December 11, 2018

Bruno Pigott, Commissioner
Indiana Department of Environmental Management
100 North Senate Avenue
Indianapolis, IN 46204-2251

Re: Proposed Infrastructure State Implementation Plan Related to the 2015
Ozone NAAQS.

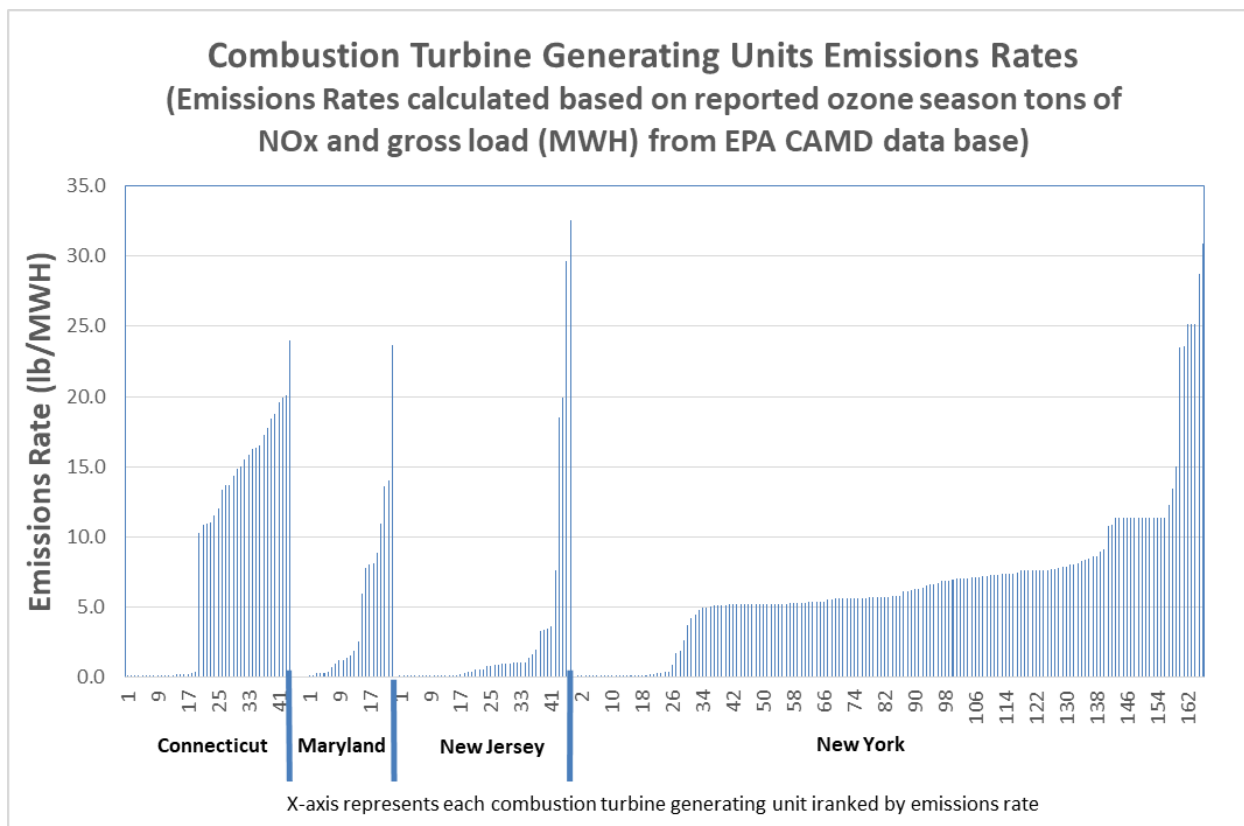
From the chart set out below you will note that states within the OTC and specifically New York, New Jersey, Connecticut and Maryland have a much greater reliance on the use of simple cycle combustion turbines with very high emissions rates than is the case with Indiana. While MOG has not reviewed (or seen) the basis for the OTC conclusion that control or replacement of “old” units is “cost effective,” such a strategy may indeed be cost-effective within the OTC, but would not be cost-effective for other states that do not have the same degree of reliance on high emitting combustion turbines as apparently is the case in OTC states. This comparison between units in these OTC states is illustrated in the following chart:

Given the significance of the need for and cost effectiveness of local controls in the states of New York, New Jersey, Connecticut and Maryland, MOG urges that IDEM emphasize that no further emission requirements are necessary from Indiana to satisfy the requirements of CAA section 110(a)(2)(D)(i)(I) unless and until additional these simple cycle generators and other local controls in these Northeast states are satisfactorily addressed.
